**CITY OF SAINT PAUL
HERITAGE PRESERVATION COMMISSION STAFF REPORT**

FILE NAME: 244 East 4th Street (used 240 East 4th Street for Pre-Application Review)

HPC SITE/DISTRICT: Lowertown Heritage Preservation District

CATEGORY: new construction

1 Exterior Elevation - East
1/8" = 1'-0"

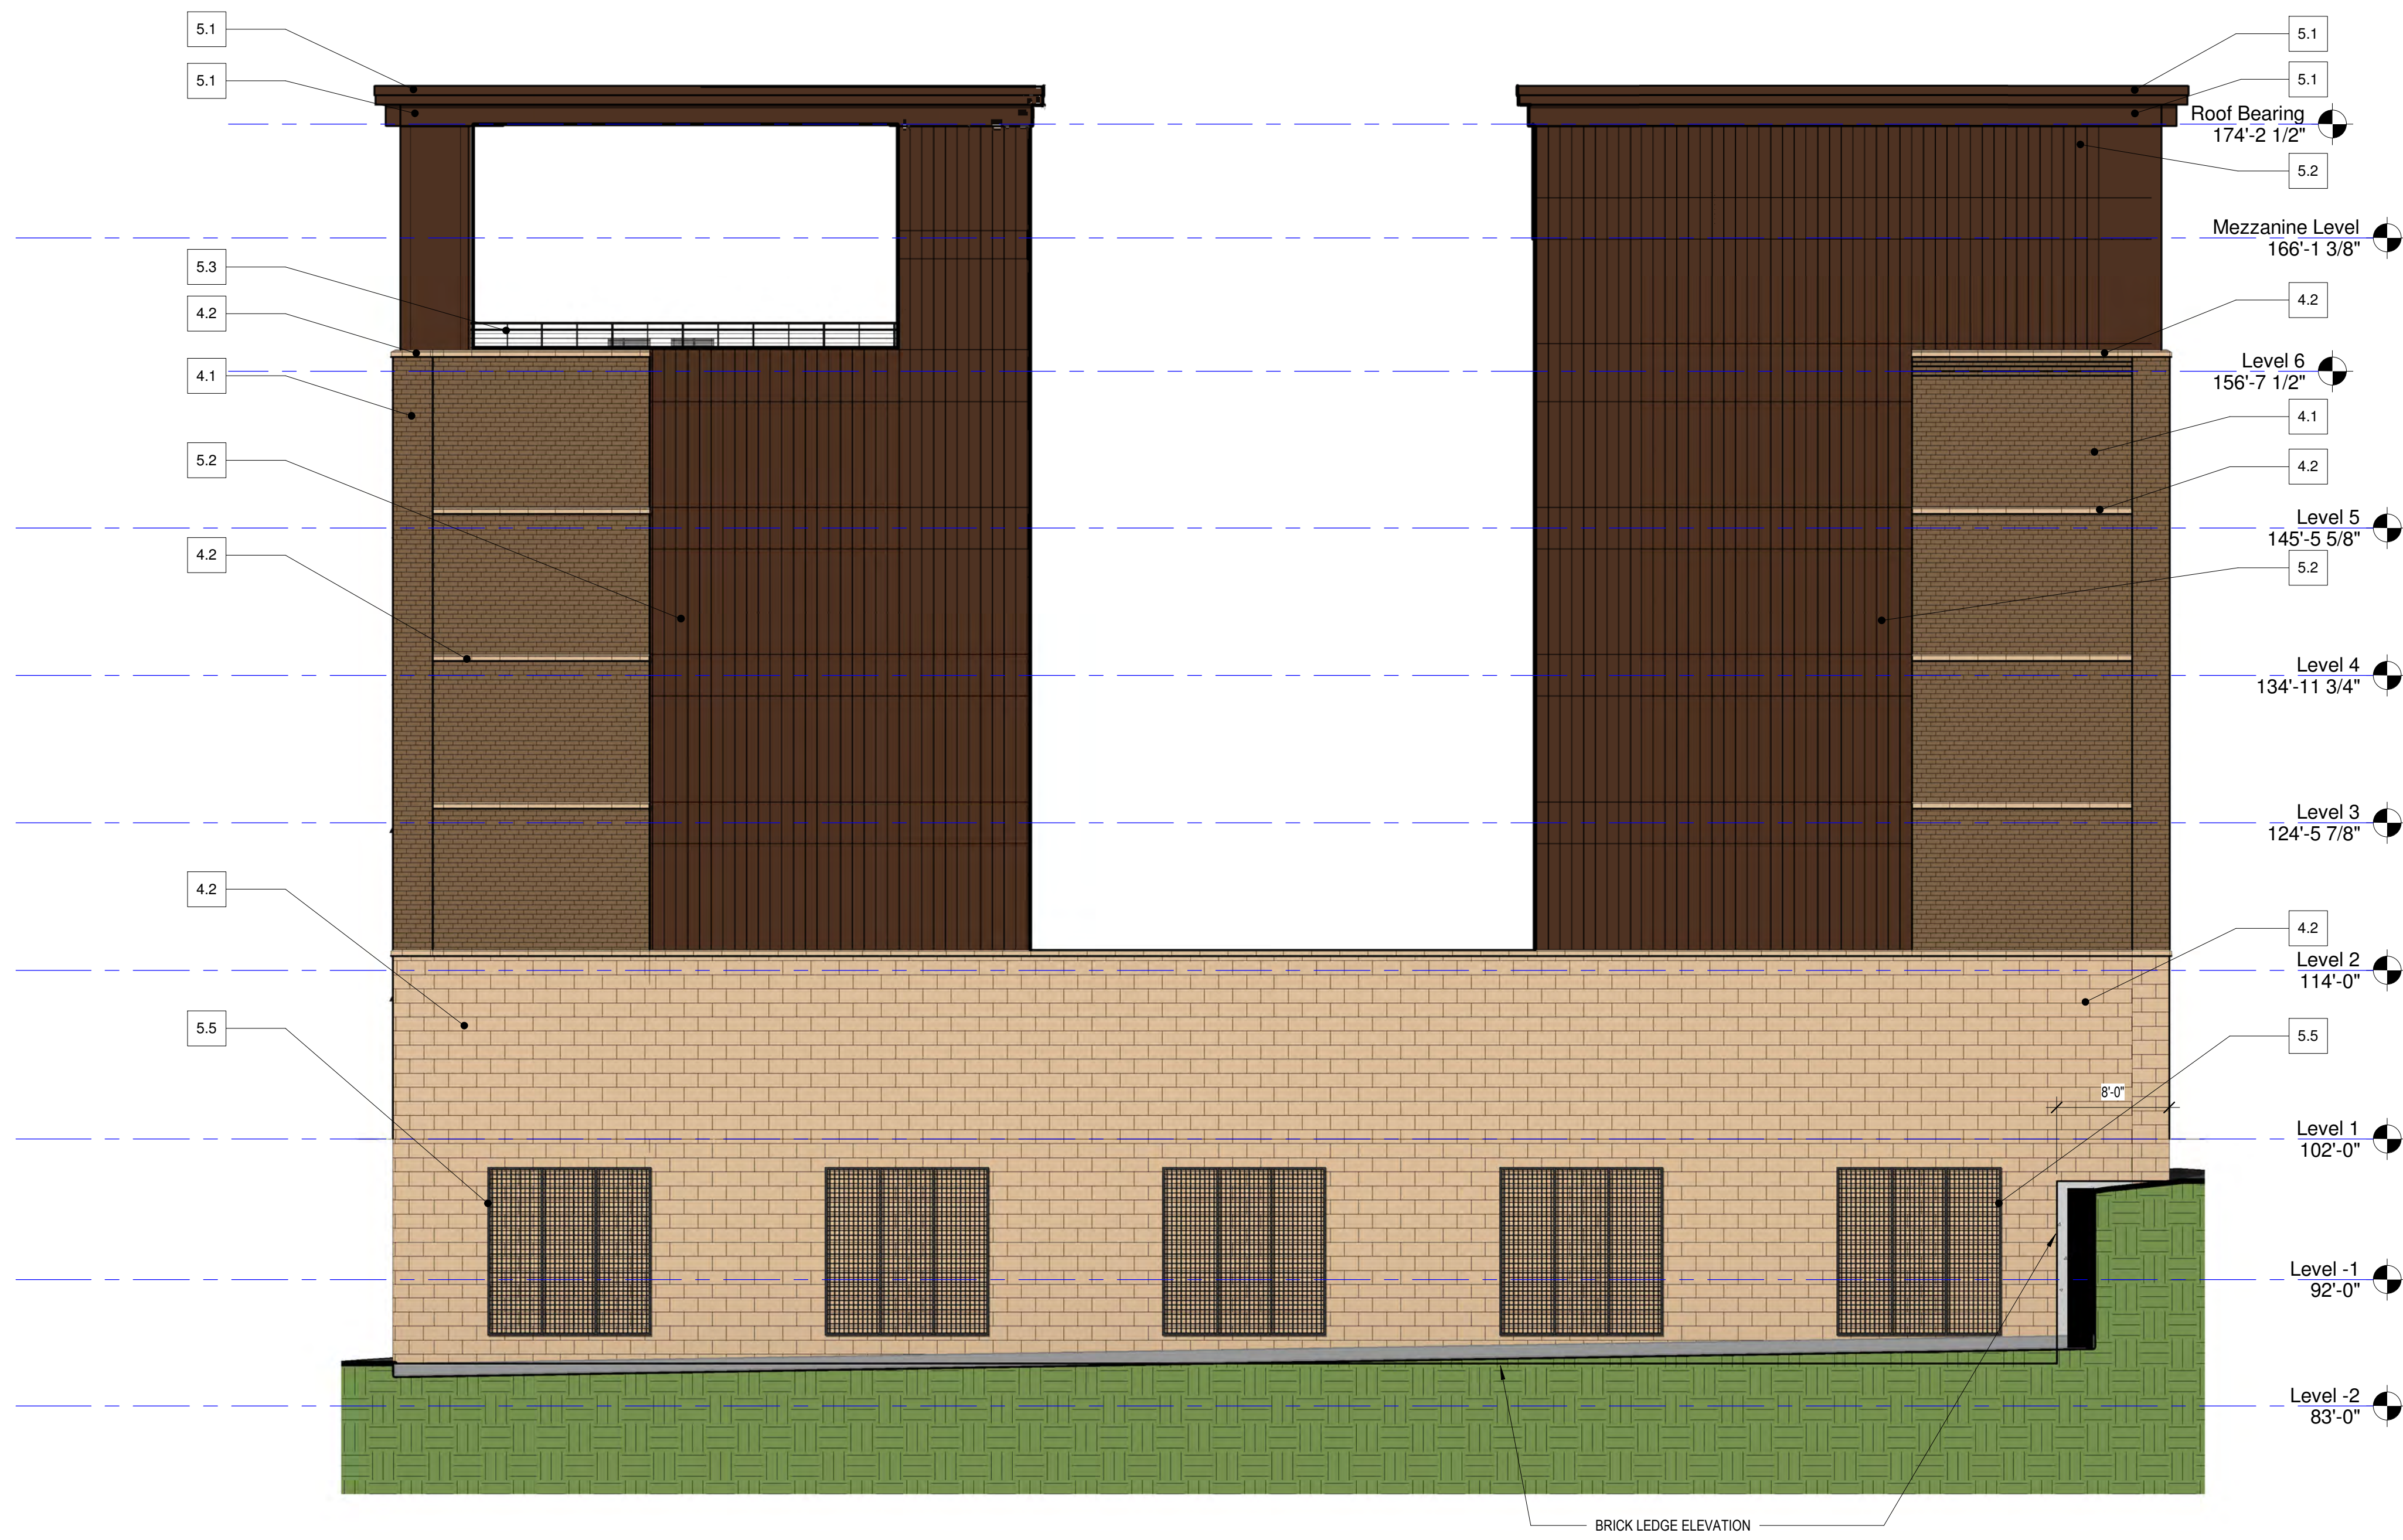
The guidelines call for materials to be used that are most prevalent in the District which is natural brick usually of dark red, buff or brown colors and that more detailing be incorporated with new construction than in typical modern commercial buildings. The guidelines do not distinguish between primary and non-primary elevations when addressing materials and detail, however, as with traditional buildings the detailing and material often changes for non-primary elevations. Typically a common brick would be used for these elevations. The proposal continues the main elevation design and materials to the south, alley elevation. This is acceptable; however, it is unusual to have storefront-type windows that are raised above grade. The HPC may want to discuss using more punched windows at the alley.
